Product Support Bulletin 2003-009

Maintenance of Way ~ Work Equipment Bulletin

DATE:	October 28	3, 2003	
SUBJECT:	Manifold Guard Kits – 98410178 (Machines with Pressure Filter) 98410179 (Machines without Pressure Filters)		
RATING:		CTIVE n is required)	ALERT (Potential Problem)
		RMATION n is optional)	x PRODUCT IMPROVEMENT (Enhance Product)
MACHINE MODEL(S):		99C Spike Driver (24-volt Machines)	
SERIAL NUMB	ER(S):	410201-410423	
SUMMARY:			s over Hydraulic Valves mounted on frame construction with Lexan® windows lenoid LED indicators.
OPERATIONAL	L IMPACT:		her and helps to prevent electrical failures rical connections on the valves.
ACTION:			bolted to the manifolds using the manifold nount to the brackets and can be removed the valves is required.
		Two different kits are available Filters and 98410179 for mach	e: 98410178 for machines with Pressure nines without Pressure Filters.
			ntirely of Lexan® may be individually guards. See Page 2 for part numbers.
WARRANTY:		None

Typical Manifold Guard Installation

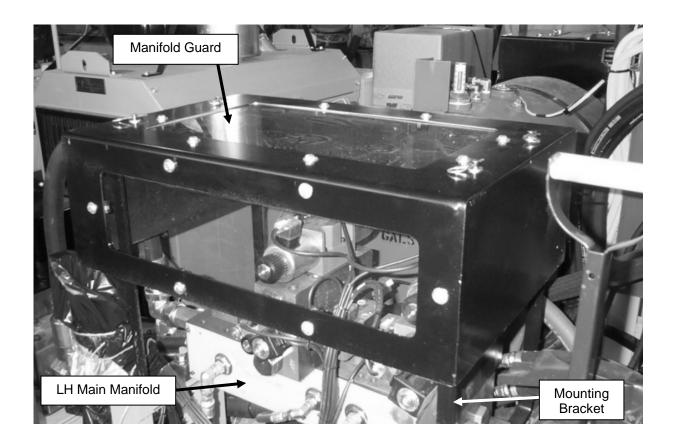
(LH Main Manifold shown – Propel and RH Main Manifold Guards are similar)
